PCN # ESW490-34 – TO-220AB non-isolated On Portfolio Thyristor Wafer Manufacture Site Transfer

## Product/Process Change Notice (PCN)

# PCN Report

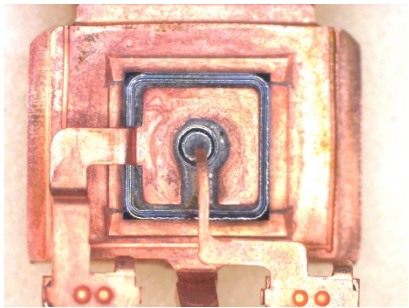
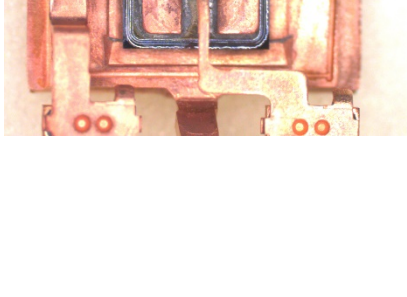
Internal assembly structure of new site wafers is slightly different with structure of existing wafers.  
 Details please refer to below list.

Existing	After	Affected Product Family
		MCR8Sxx/MCR72-xG/MCR310-xG/ C122F1G/MCR218-xG/2N639x/ MCR12xx/MCR68-xG series
		2N640x/MCR16xx/2N650x/MCR25xx/ MCR69-x/MAC8xx/MAC12xx/ BTB08-x00/BTB12-x00/BTB12H-x00/ MAC9xx/T2500/T2800/MAC228Ax/ MAC210Ax/2N634x/MAC3030-xG/ MAC15Ax/MAC16xx/BTB16-x00/ BTB16H-x00 Series
